RotorSport UK Ltd

Service Repair Request and Evaluation/Approval

Repair No.: 016 Iss2, 30.11.18	CCAR No.: CCAR-044 Mod approval No: MC-234	Repair classification: MAJOR or MINOR
Aircraft type: MT-03 and MTOsport (all aftermarket only)	Aircraft serial No. OPEN (first application G-CEHN RSUK/MT03/008

This repair scheme SRA-016 has been developed to enable repair of such damage. It may only be implemented by RotorSport UK Ltd

Details of the repair

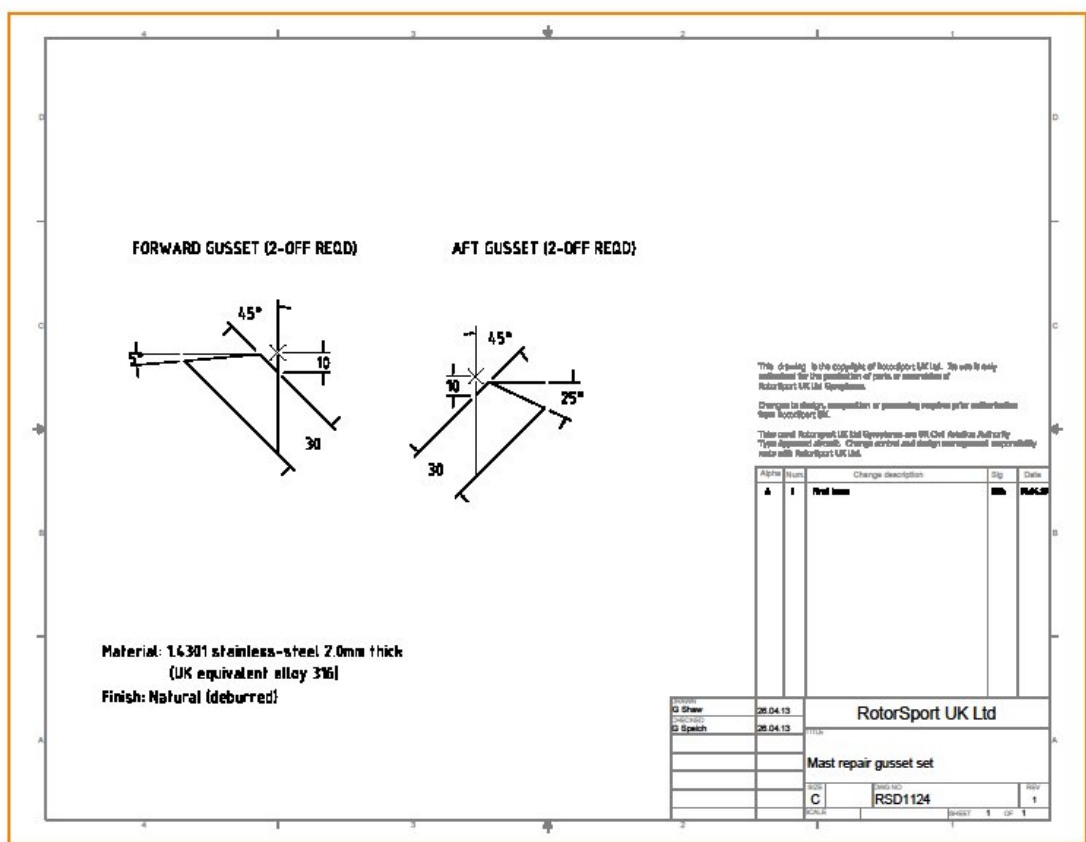
(i) Make good the cracks and add reinforcing gussets at the lower mast/keel interface

With the suspension bow removed thoroughly clean the intended weld area with Amberclene LO30 solvent (RSD4655) and 180 grit "Scotchbrite" abrasive pad. Using a small power-tool (e.g. Dremmel) grind-out the length of the crack with an abrasive disk 0.75mm thick then remove all grinding debris. Weld-up each prepared crack in one continuous pass (see 1.3. below for welding set-up)

Clamp in place the four gusset pieces of RSD1124 and fillet weld the joint interfaces in accordance with RSD7225.

Gusset prepared

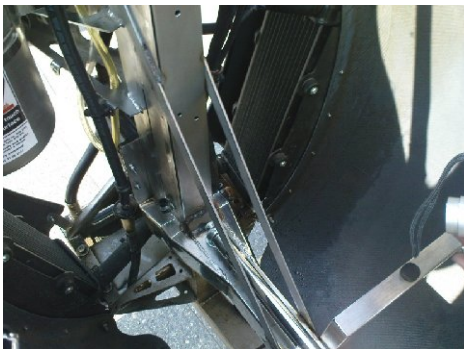
(ii) Check the mast alignment (and adjust if necessary), then make good the crack and add the reinforcing gusset at the upper mast/keel interface (by the method previously approved under MC-115/SRA-004).

The mast alignment is determined by the centre-line of the fore-aft keel and an angle to the keel of 5 degrees (MT-03) or 6.5 degrees (MTOsport). The technique for straightening is defined and previously approved in MC-115, associated compliance statement RSUK0165 Iss2, and Service Repair SRA-004.

The gusset is manufactured by hand from a section of 2mm wall thickness 50mm square box-section stainless-steel 1.4301 and is welded in place with compatible filler wire (see Welding requirements below)

View of straps welded in place The straps are welded at 35 degrees to the mast, as detailed in RSD7178.

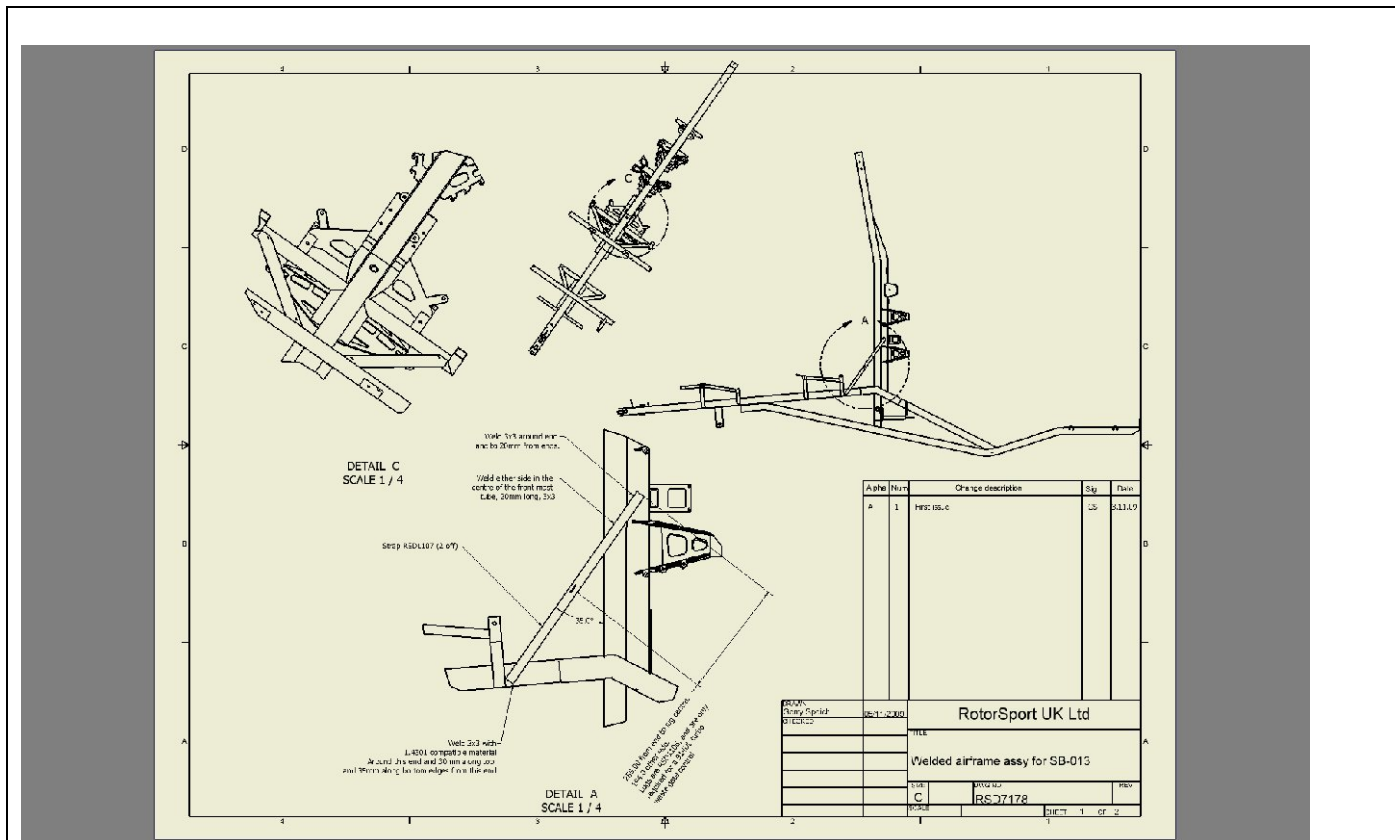
(iii) Add the reinforcing straps between the mast and keel (by the method previously approved under MC-115/SRA-004, also forming part of the upgrade from 450kg to 500kg MTOW approved under MC-070). Detail instructions are given in the drawing RSD7178 below

Issue 2 content - alternative lower gusset arrangement when a native MTOS airframe is under repair.

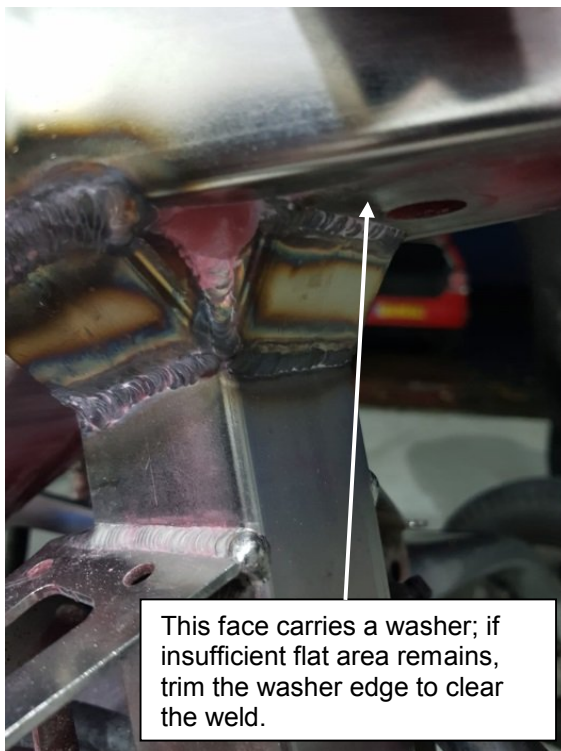
The MTOS airframe (which is approved for 500kg MTOW with the uprated suspension bow) already has the reinforcing straps between the keel tube and main mast section. It is therefore permissible to delete the requirement for items (ii) and (iii) above provided there are no cracks at the base of the mast (i.e. where the upper gusset would be placed). In this case a stronger arrangement of four lower gussets is used, changing the detail of item (i). The gusset set used is RSD1139 "Mast repair alternative lower gusset set". These are triangular pieces cut from a section of 50 x 50 x 2mm stainless-steel box section (same as the mast section, alloy 1.4301) as shown on page 9 and when in place surround the lower mast/keel-tube interface, as can be seen in the photos below. Adjust the length to clear the weld, and shape to suit the area to be welded. The gusset vertical angle should be 30-45deg.

The other requirements of embodiment under this SRA-016 remain unchanged.
